## **Finding of No Significant Hazard**

In a license amendment request dated December 23, 2021, the NIST Center for Neutron Research (NCNR) requested an amendment to the facility license Technical Specifications (TS). As required by 10 CFR 50.91(a), the following analysis is presented to show the proposed amendment does not create a significant hazard using the criteria of 10 CFR 50.92(c).

## Description of tests in proposed changes to TS 3.9.2.1

**Figure 2.** Fuel element latched in position H-7 (note: in this prototype the fully latched green triangle is about  $2^\circ$  off of the actual fully latched position. This will be corrected in future prototype and design development.)

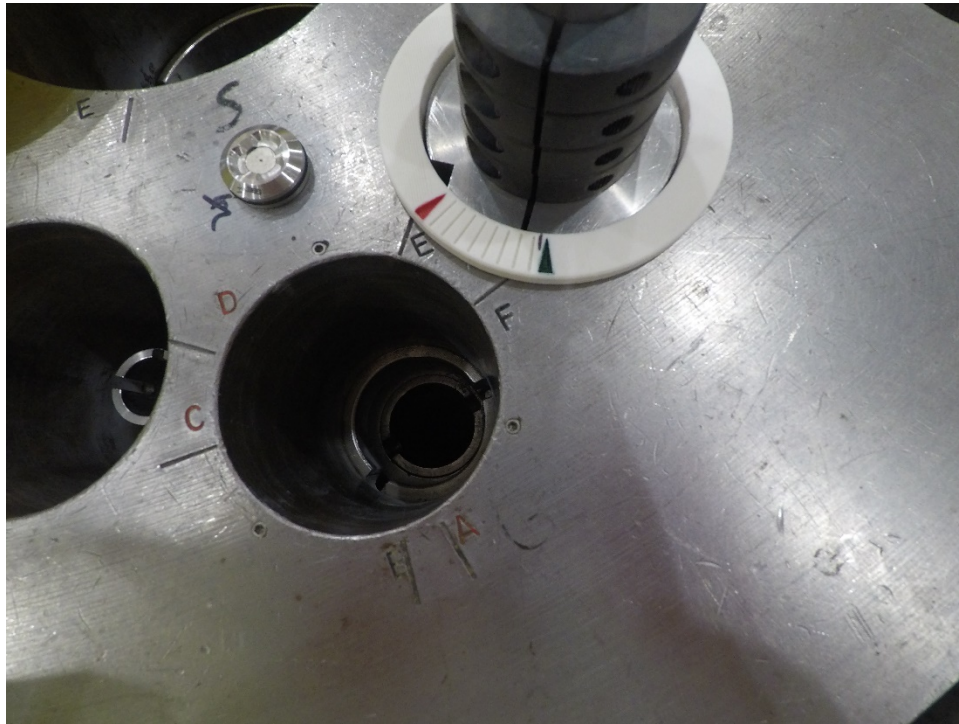
Prior to removal of the tool from the head, the azimuthal position of the collar affixed to the tool is checked against fiduciary marks on a sleeve inserted into the element position in the index plate. Figure 2 shows the rotational check on a fully latched element against a prototype sleeve that is slipped into the tooling plate and that has fiduciary marks indicating latched (green triangle) and fully unlatched (red triangle). These marks are true fiduciary marks in that they relate back to machined notches in the bottom of the tooling plate that are true to the cartesian axis system of the upper grid plate. Figure 3 shows the rotational check of the same element with the latch bar in a position that is still within the notch, but rotated in a clockwise direction. Note that, although latched, this element *would be assessed as unacceptable* and would need to be rotated so that the indication aligns with the green fiducial reference mark. Obviously, elements found rotated further clockwise (and likely out of the notch) would also be found unacceptable. Variations of rotation angles due to tolerances in the upper grid plate and notches are being evaluated and will be clearly indicated on future designs of the marked sleeve to give a clear “passing” criterion.

- (1) Rotational check of the element head after final latching rotation by the refueling tool, followed by
- (2) Visual inspection of the fuel element head or latching bar verifying that the element is in the latched position.

**Figure 4.** Video capture of element in latched position (core position I-6)

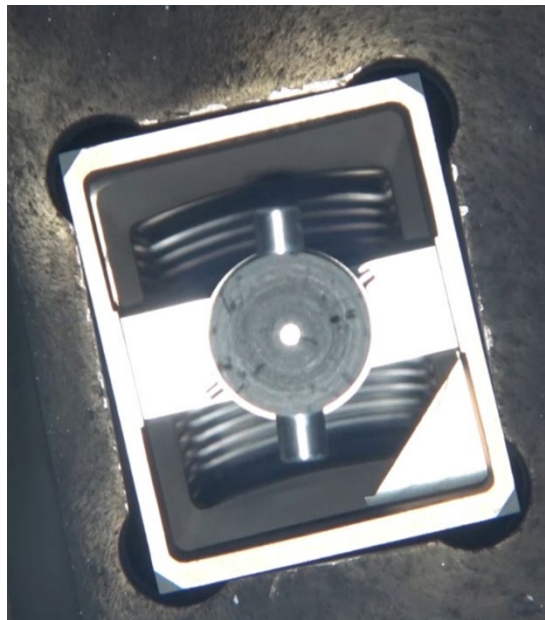
Photos of the video results of a test with a fully latched element in core position I-6 is shown in Figure 4. A photo of the H-7 element rotated about 6° off of full counterclockwise (the same as in Figure 3) is shown in Figure 5. The difference between the two can be easily seen, as the “ears” of the rotated element are clearly off perpendicular and would be rejected. Further rotation clockwise would also have the latch bar coming into view. As in the rotation check, evaluations are being made to clearly define acceptable visual check angle deviations.

After the rotation checks are complete and all tools are in their stowed positions, a newly constructed camera system is set to “record” and is then placed into the fuel transfer system (As if one were introducing a fresh fuel element). This camera system is then systematically moved through the fuel transfer system and in turn positioned immediately over each element position. Once the camera has traversed the entire system it is retrieved. The video is uploaded and reviewed by an operator. The operator, along with a second person, will verify and document that each element is shown to be latched. A detailed procedure, Maintenance Procedure 5.39, Visual Check of Fuel Element Latch Bar, has been drafted and will be included in updated refueling procedures.
